# Standard 4

# Summary of Standard 4 Concerns

SWPPP on p. 56 – 67 of CUP

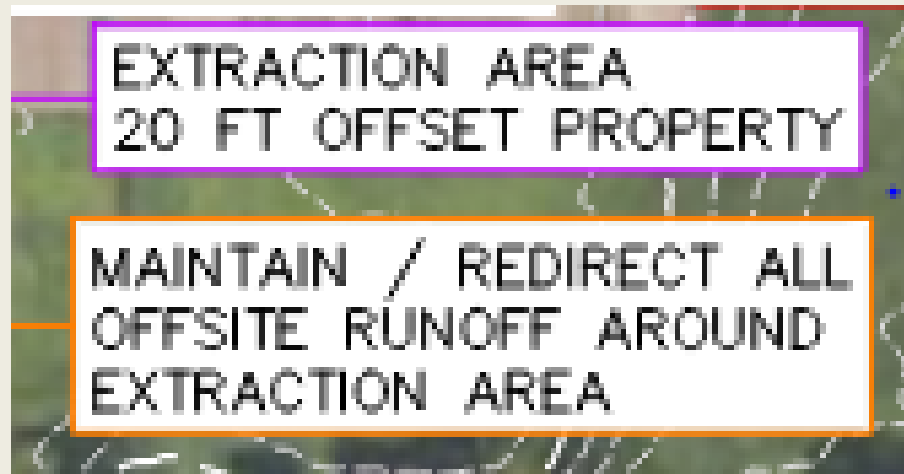
This is for existing 9 acre pit. Date: Mar 2018

***An updated SWPPP should be in place.***
